SUBDIVISION COMMITTEE
METROPOLITAN AREA PLANNING COMMISSION

STAFF REPORT
(Preliminary Plat)

CASE NUMBER: S/D 95-34 BAY COUNTRY 2ND ADDITION

SURVEYOR/ENGINEER: Baughman Company, P.A., 315 Ellis, Wichita, KS 67211

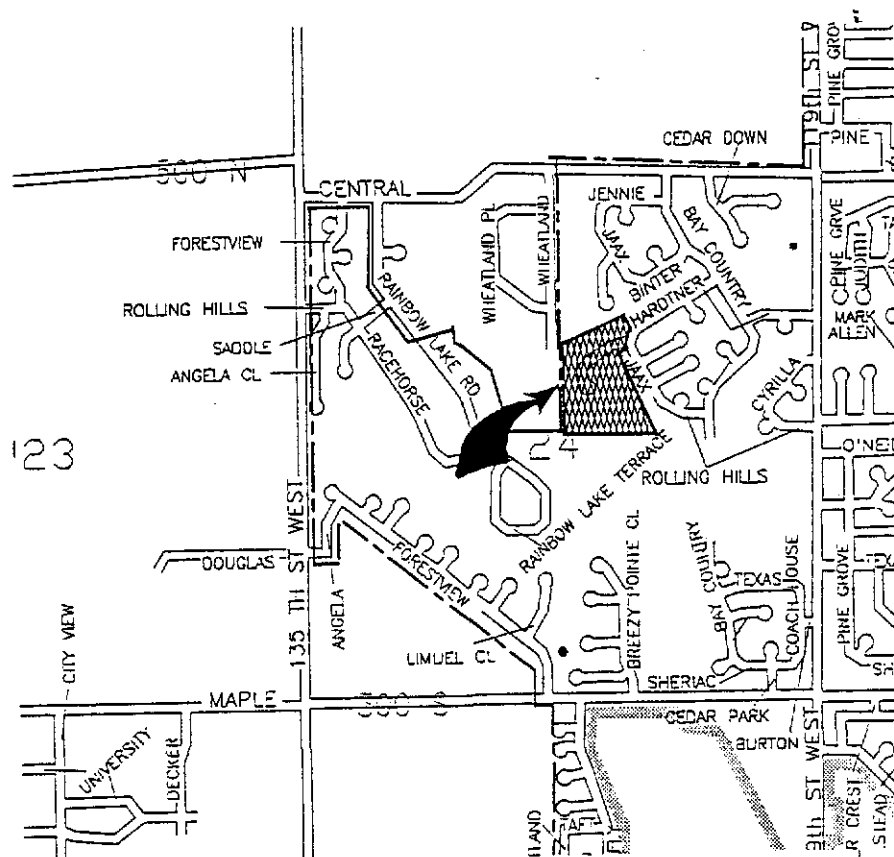
NOTE: This preliminary plat appears to be a replat of a portion of Bay Country Addition that currently has 16 lots (Lots 53-68) along Hardtner Circle (a 633 foot long cul-de-sac) and contains Reserve "C". The proposed plat would plat 39 lots, significantly reducing the area of the reserve and reverse the drainage pattern.

- C. The applicant shall guarantee any drainage improvements, required by the platting of this property, including the construction of storm sewers, and submit a revised drainage plan for review and approval by Public Works.

- D. The applicant shall guarantee the paving of these street segments:
The proposed street is approximately 1,498 feet in length, which exceeds design standards contained in 7-20/(R) (pp.7-16-17):
The platting of a street with a single point of ingress and egress may have a length which exceeds the design standard of 600 feet, but is not more than 1,200 feet, provided one of the following conditions exists:

- E. Staff would have preferred to extend Rolling Hills Circle eastward to Jaax or southward to Jayson Lane to create a loop street. The applicant indicates the lots west of Jaax are under contract, so to extend Rolling Hill's's Circle over to Jaax would require the applicant renegotiate an existing contract. It does appear that Reserve "A" could be moved to the southern end of this Tract, thereby reducing the length of roadway needed.

- H. If for no other purposes other than maintenance, a means of access shall be provided from this site's street system, to Reserve B. This plat is basically providing no means for either residents or persons need to access this Reserve, to directly enter this Reserve. The final plat shall therefore provide a 10 to 20 foot wide extension over to the adjacent street (Hardtner-Wheatland-Rolling Hills Circle).

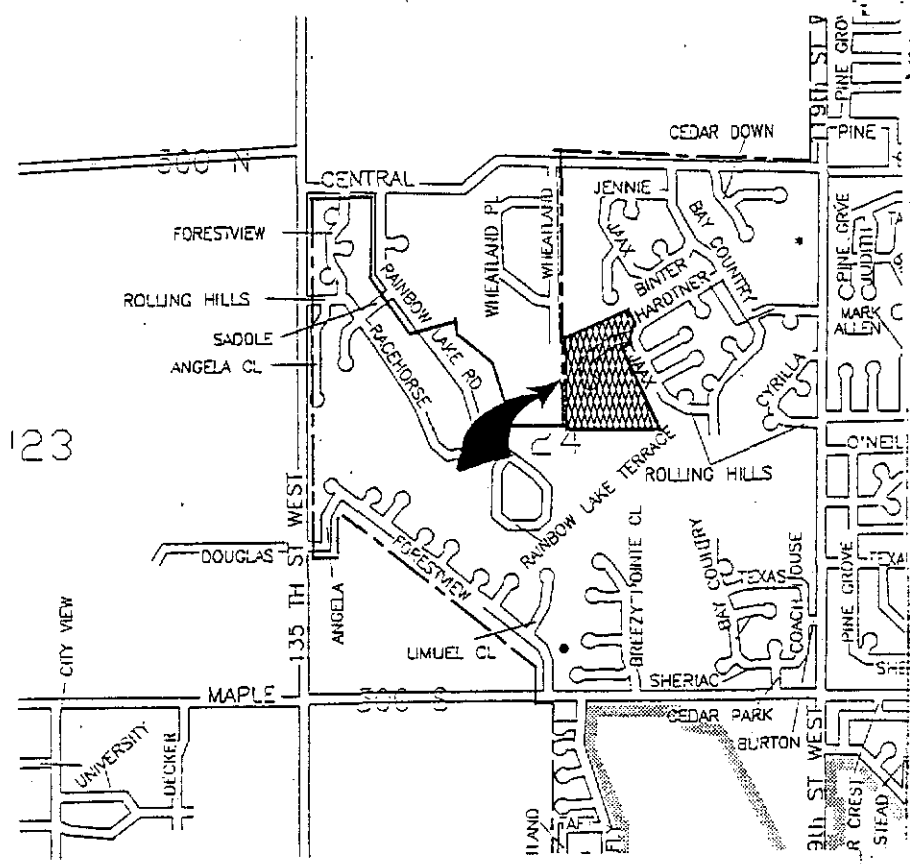
NOTE: This plat supersedes the Bay Country 2nd Preliminary plat submitted in May, 1995. As originally submitted, an excessively long cul-de-sac was being created. Planning recommended that a loop type street out to Jaax or Jayson Lane be considered because of safety concerns with such long, one point of entry streets. As shown by this revised plat, the applicant was able to create such a looped street by revising this plat to include previously platted properties along Jaax. As noted during review of the original preliminary plat, a major revision in a Reserve area was being made by this plat and adjoining property owners and/or homeowners associations were required to be contacted to determine if any objections existed to the proposed changes. No apparent objections have been received by Planning to these changes, with the various homeowners associations indicating actual support for the changes.

- C. The applicant shall guarantee any drainage improvements, required by the platting of this property, including the construction of storm sewers.
- D. The applicant shall guarantee the paving of the proposed interior streets. This guarantee shall also provide for sidewalk along one side of this looped street.

- F. **Fire Department - Central Inspection** need to comment on the appropriateness of the street names. The suffix Circle would apparently no longer be appropriate. Also, it should be noted if 3 separate street names are necessary for the street shown.

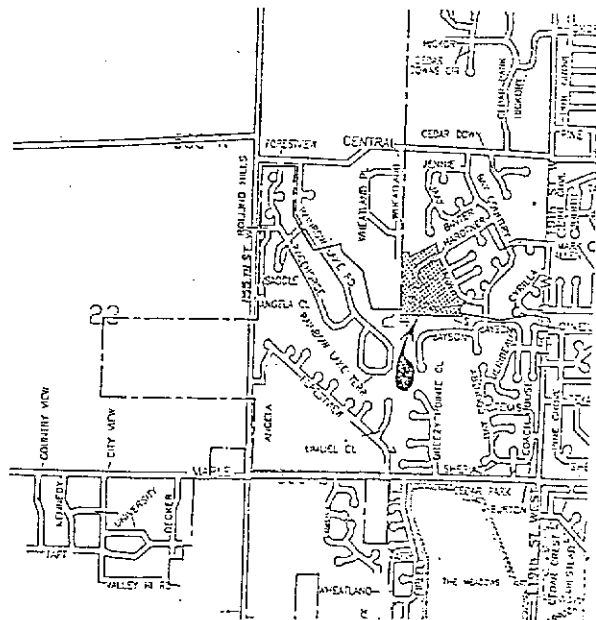
NOTE: This plat supersedes the Bay Country 2nd Preliminary plat approved July 20, 1995. Since a revision in a Reserve area was being made by this plat, adjoining property owners and/or homeowners associations were required to be contacted to determine if any objections existed to the proposed changes. No apparent objections have been received by Planning to these changes.

- F. Fire Department needs to comment on the 760-foot length of Wheatland/Hardtner which exceeds the 600-foot limit for cul-de-sac streets per the Subdivision regulations.

- G. The applicant shall submit a covenant which provides for four (4) off-street parking spaces per dwelling unit on each lot which abuts a 58-foot street (Rolling Hills Circle). The covenant shall inventory the affected lots by lot and block number and shall state that the covenant runs with the land and is binding on future owners and assigns.

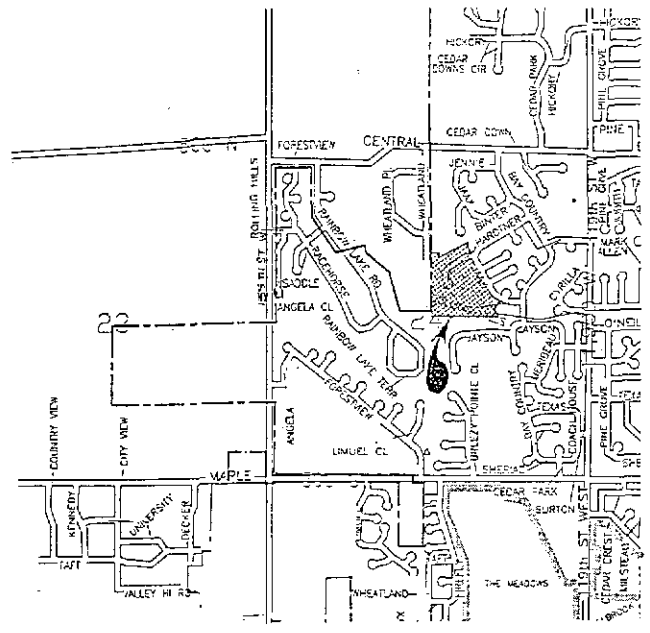
- F. Fire Department needs to comment on the 760-foot length of Wheatland/Hardtner which exceeds the 600-foot limit for cul-de-sac streets per the Subdivision regulations. *The street name "Wheatland" needs to be eliminated. Fire Department has approved the length of Hardtner which contains a 64-foot right-of-way width.*

- O. The representatives from City Engineering should be prepared to comment on the status of the applicant's drainage concept. The drainage concept is approved. Computations of the proposed detention pond are needed to determine minimum building pad elevations for the lots around the lake.
